ADDENDUM NO. 01

BCDM Architects
1015 North 98th Street, Suite 300
Omaha, Nebraska 68114

November 30, 2023

Arnold Elementary – Addition & Renovation
5000 Mike Scholl Street
Lincoln, NE 68524
&
Huntington Elementary Renovation
2900 North 46th Street
Lincoln, NE 68504
BCDM Project No. 5370-01

4 HOLLOW METAL FRAMES
A4-1 1/4" = 1'-0" 0' 1' 4" 8"

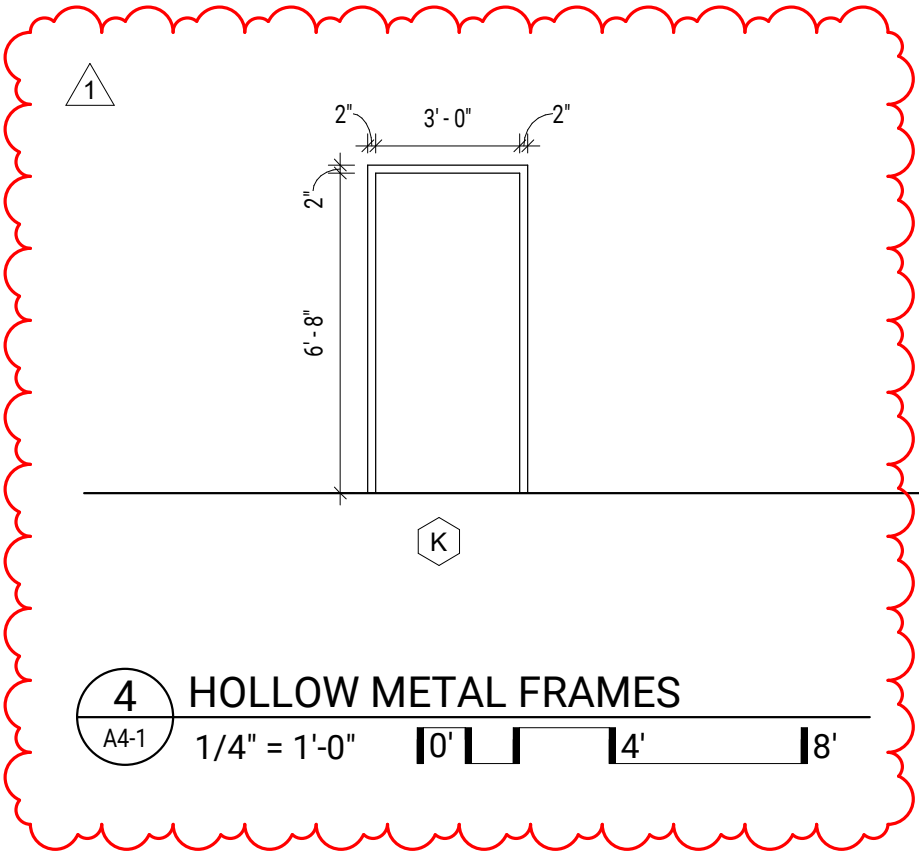
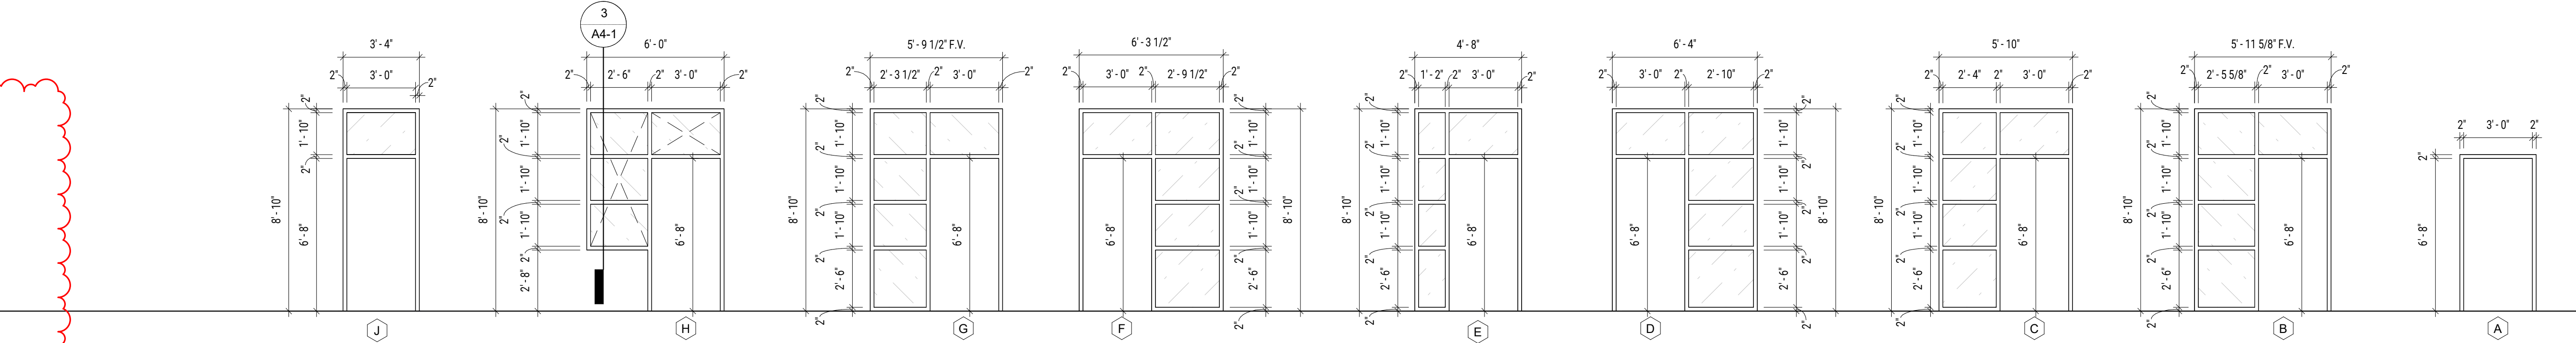
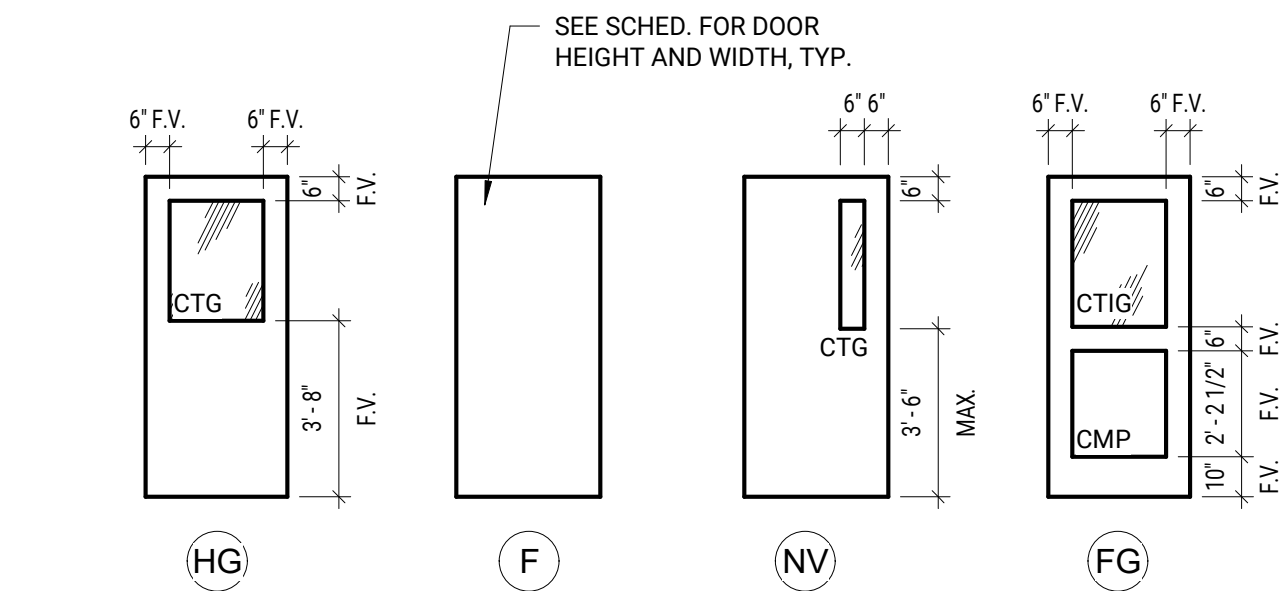
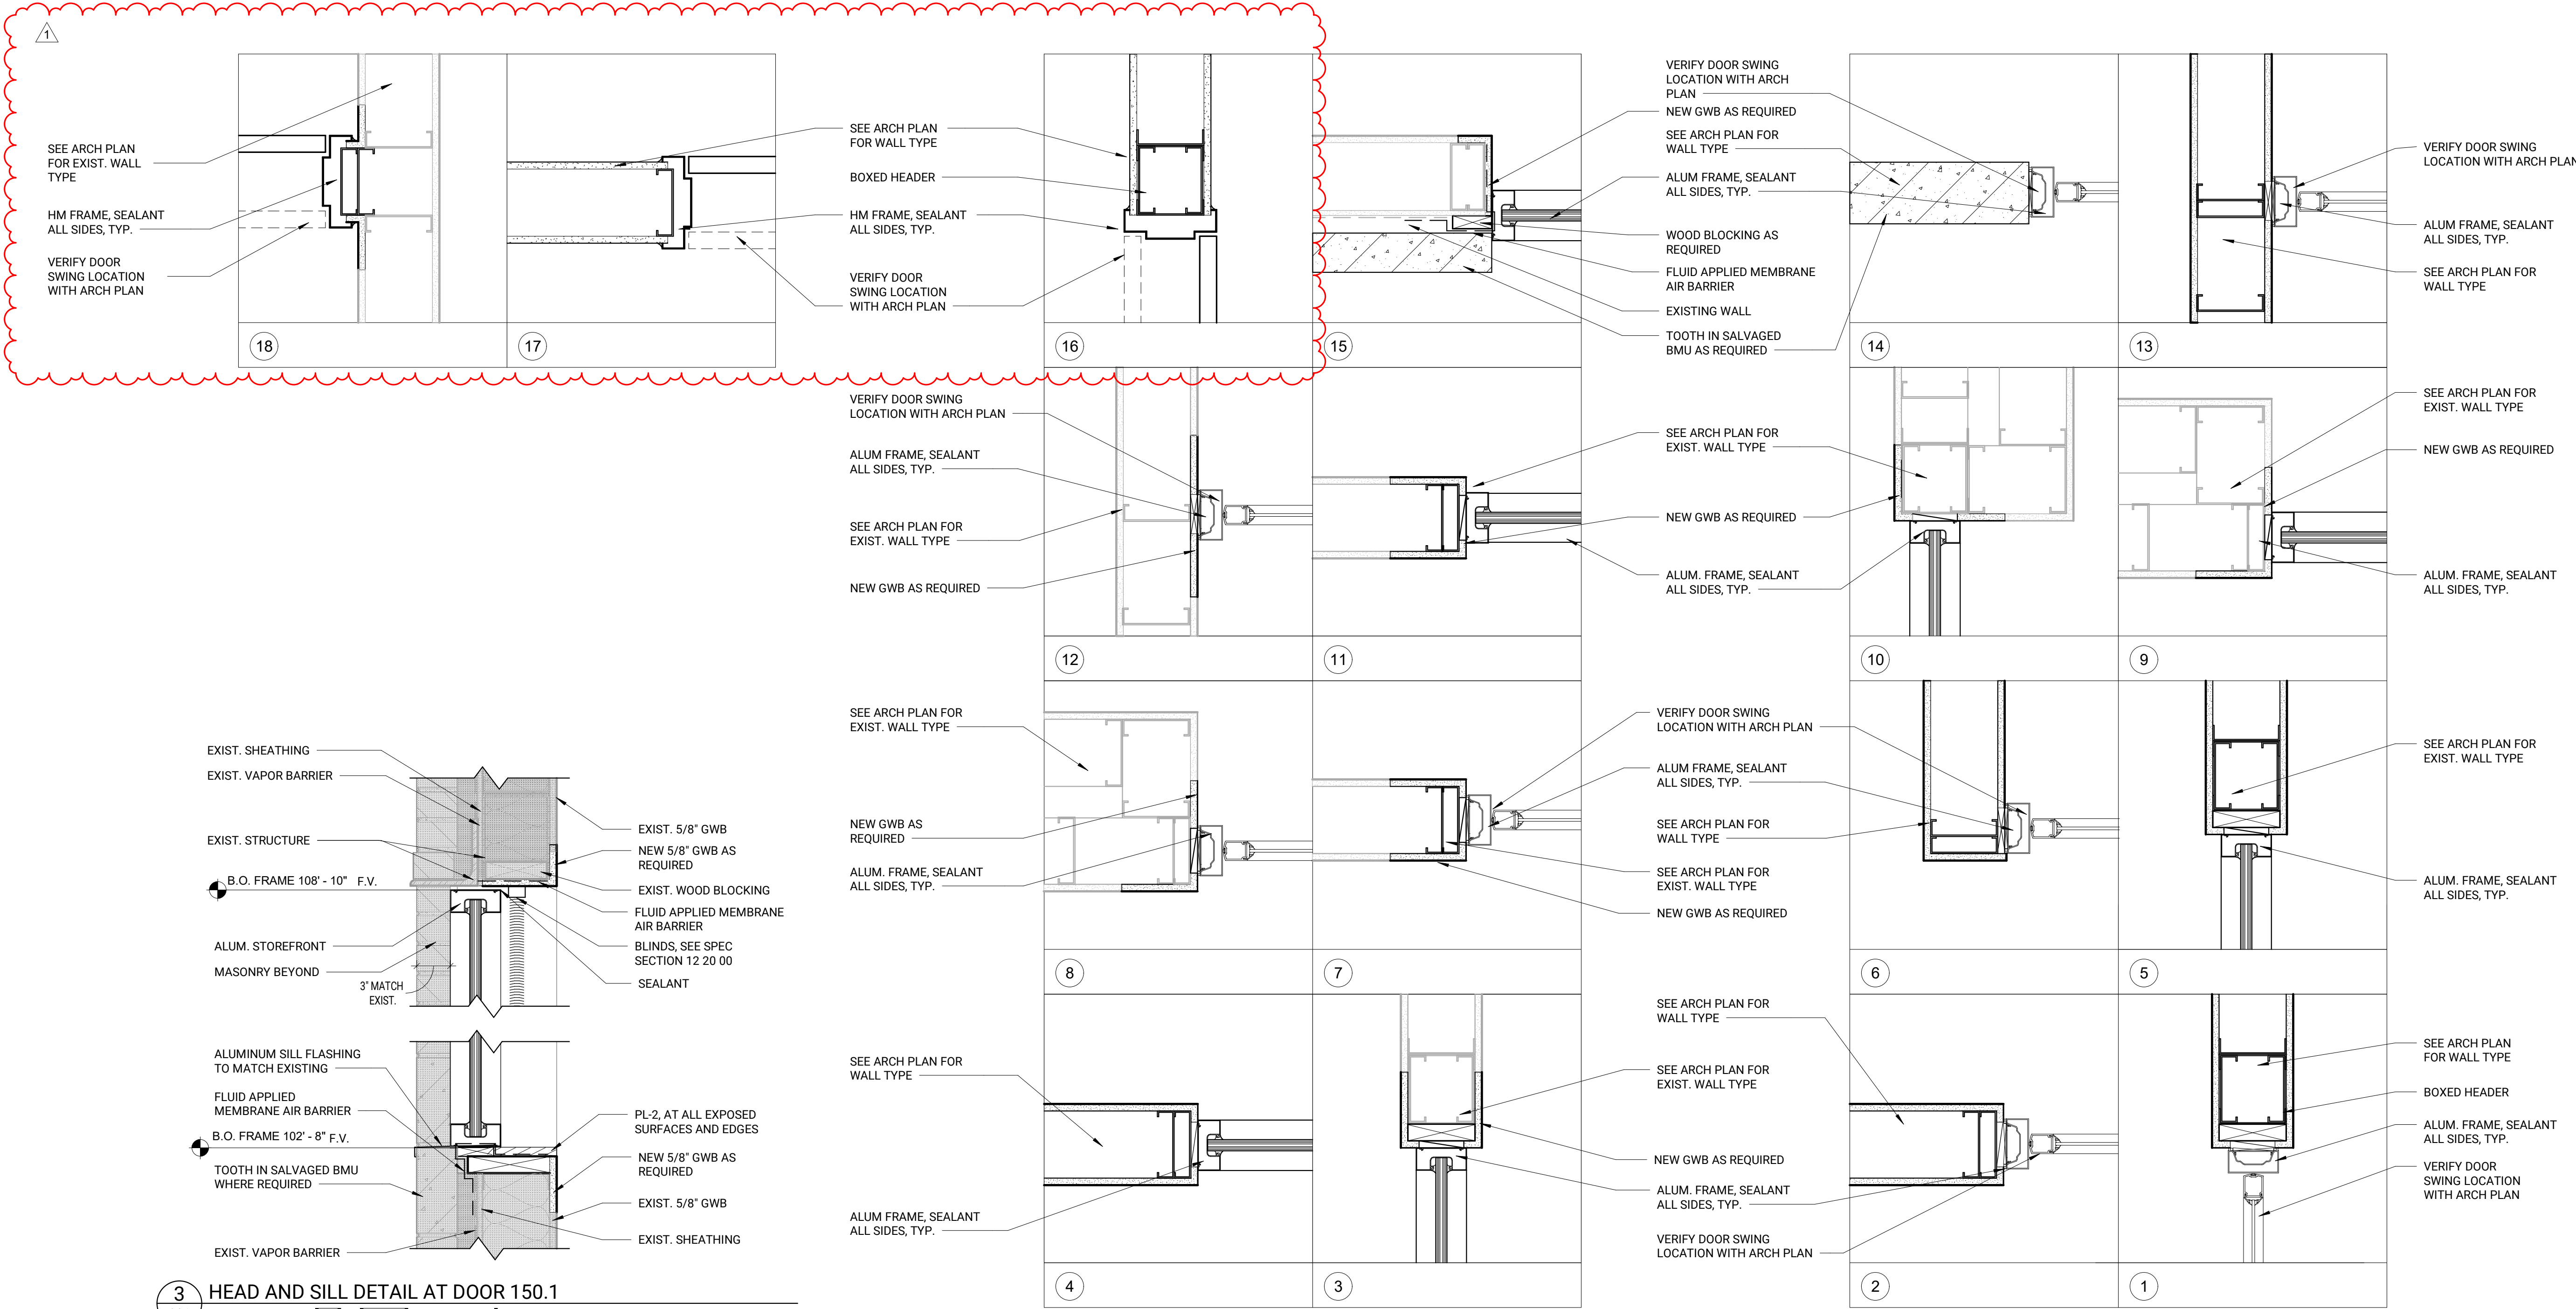
HUNTINGTON SHEET A4-1, DOORS AND WINDOWS

- a. DOOR AND FRAME SCHEDULE, adjust Door No. 144A to HM Frame Type "K with 5 7/8" depth. HM frame finish to be P-10. Adjust Head detail to 16 and Jamb details to 17,18. See attached revised sheet.
b. DOOR AND FRAME DETAILS, add details 16, 17, 18. See attached revised sheet.
c. Add Hollow metal frame Type 'K' elevation. See attached revised sheet.

MD1-1

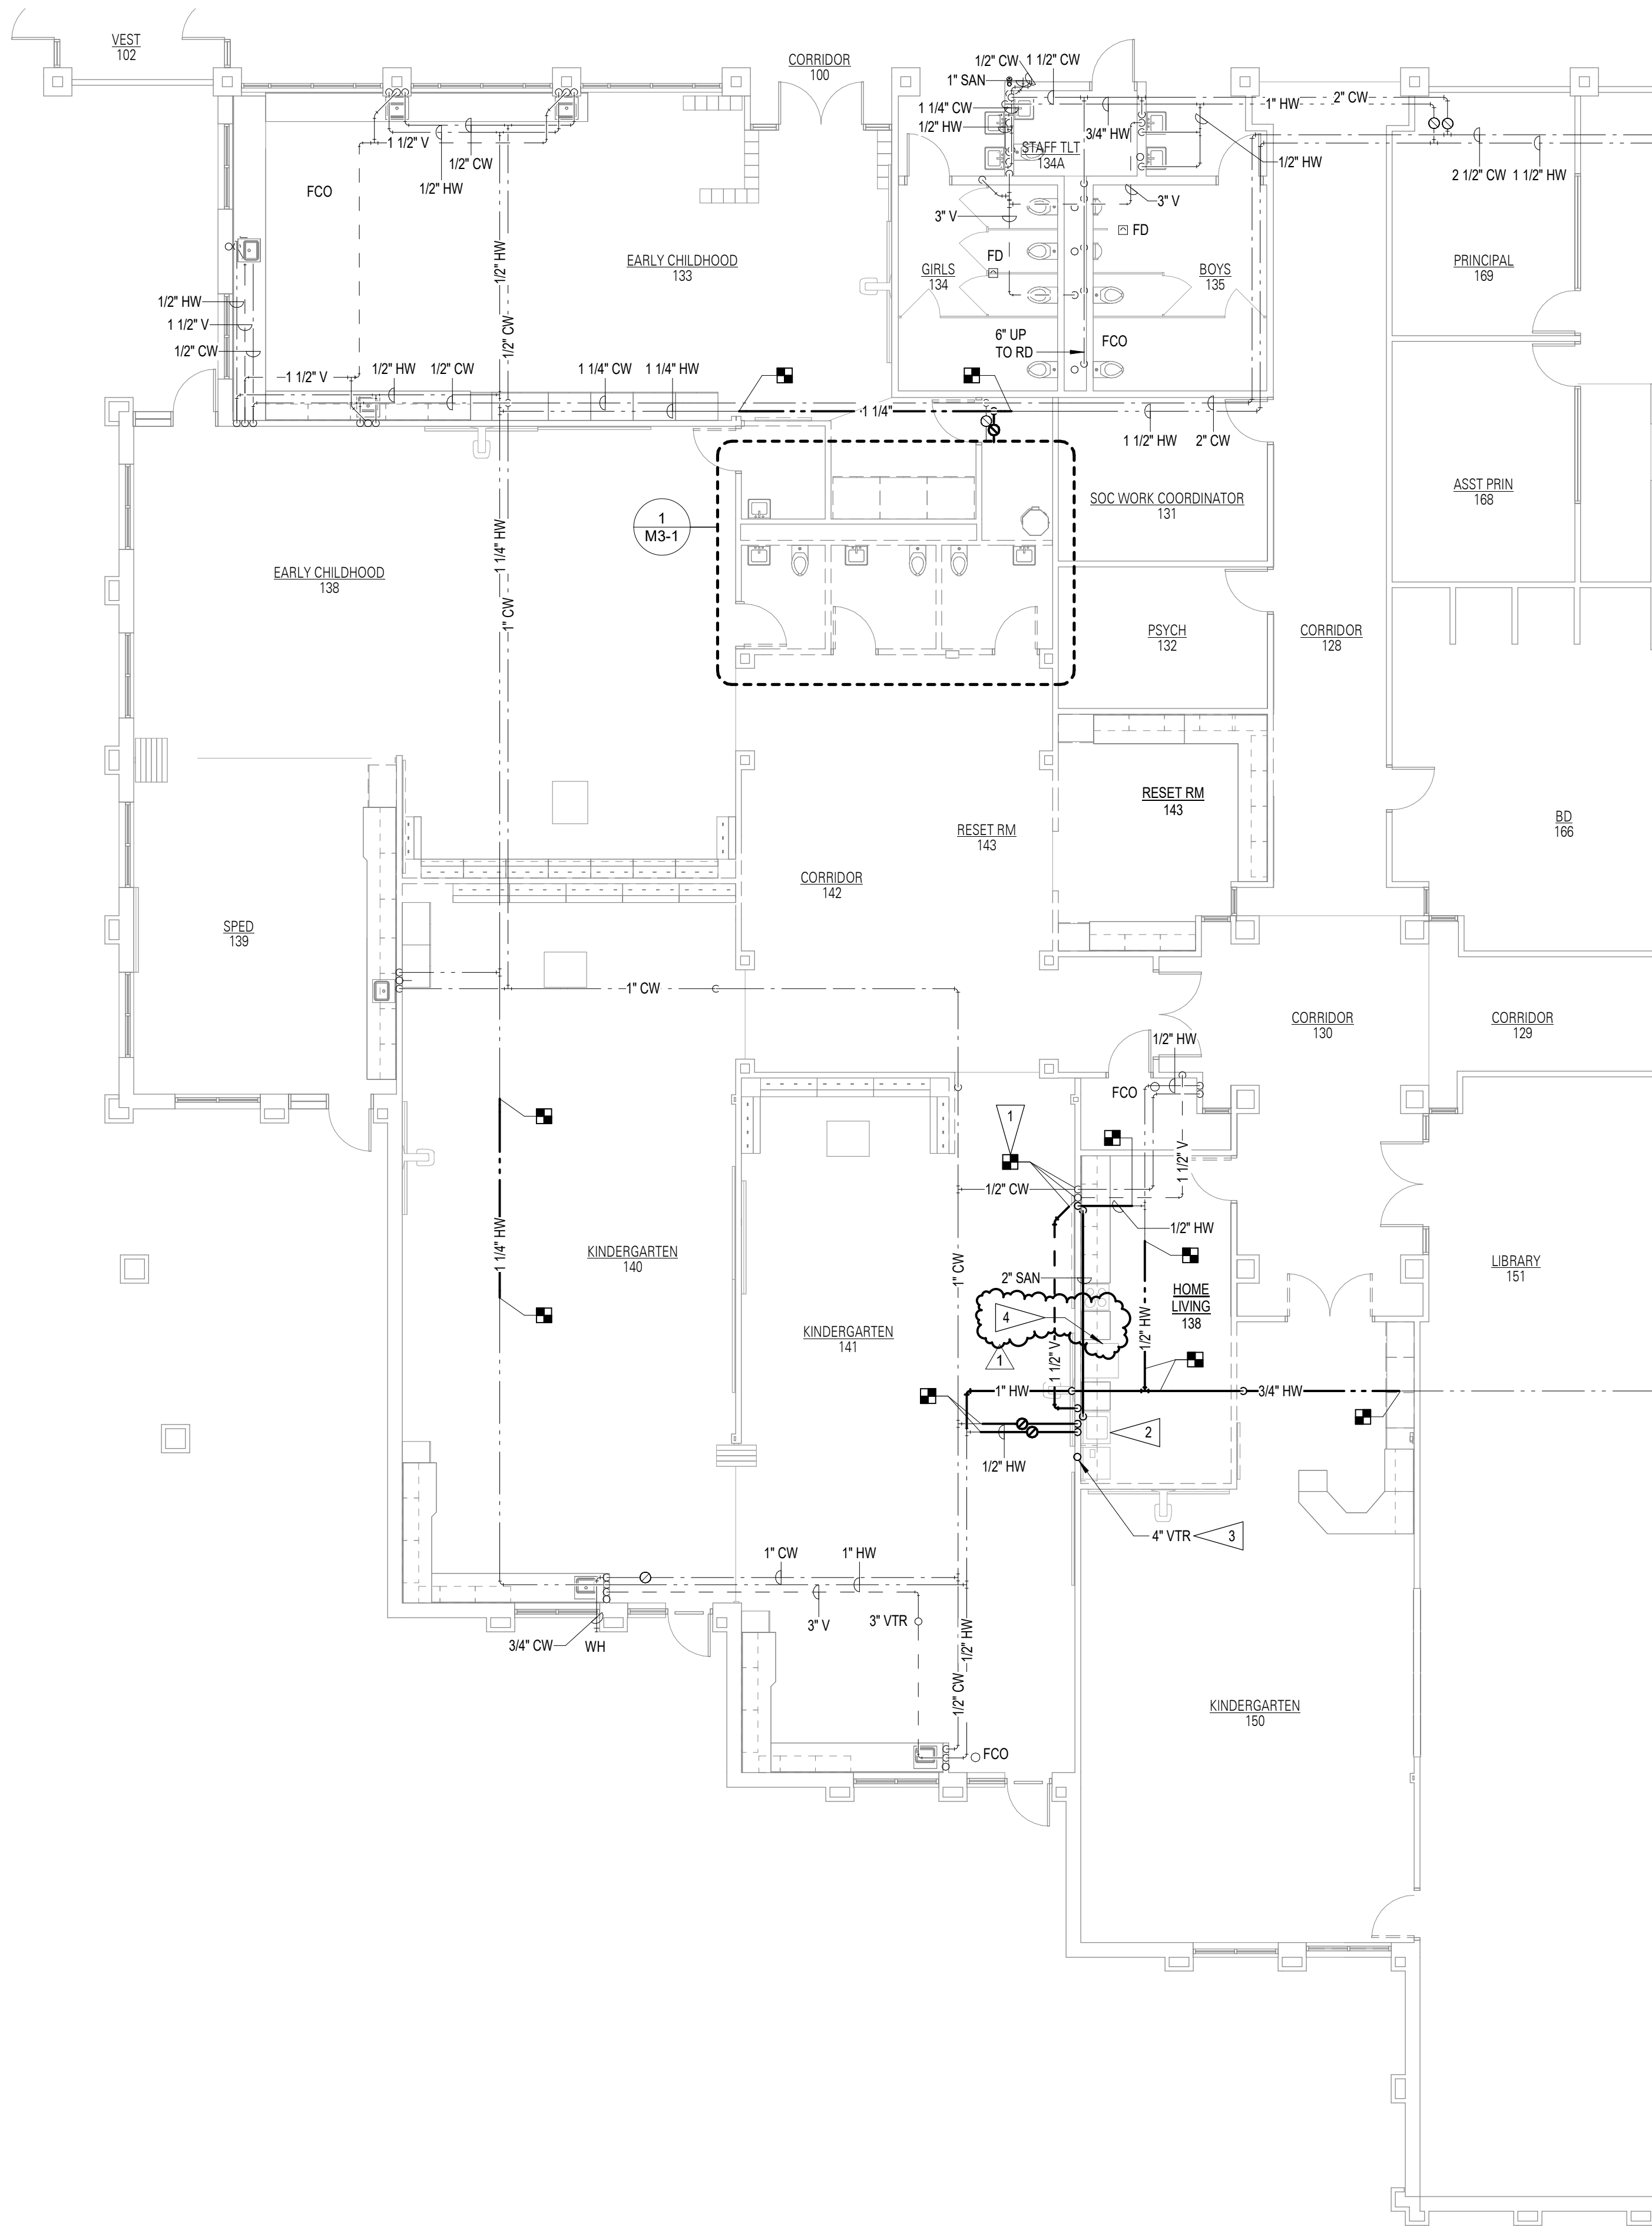
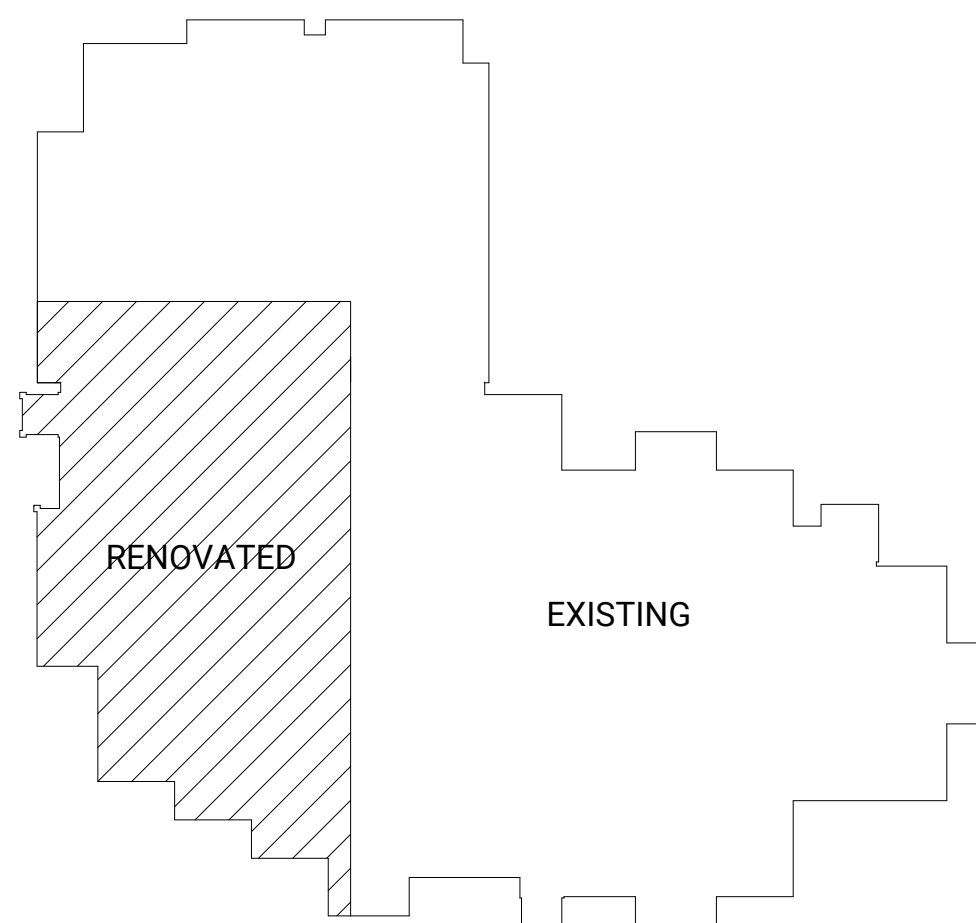
1MD1. Sheet MD1-1 – Below Grade and First Floor Plan – Plumbing Demolition

1. Floor Plan 2: Add Flag Note 4.
2. Flag Notes: Add Flag Note 4.
3. See attached reissued sheet.
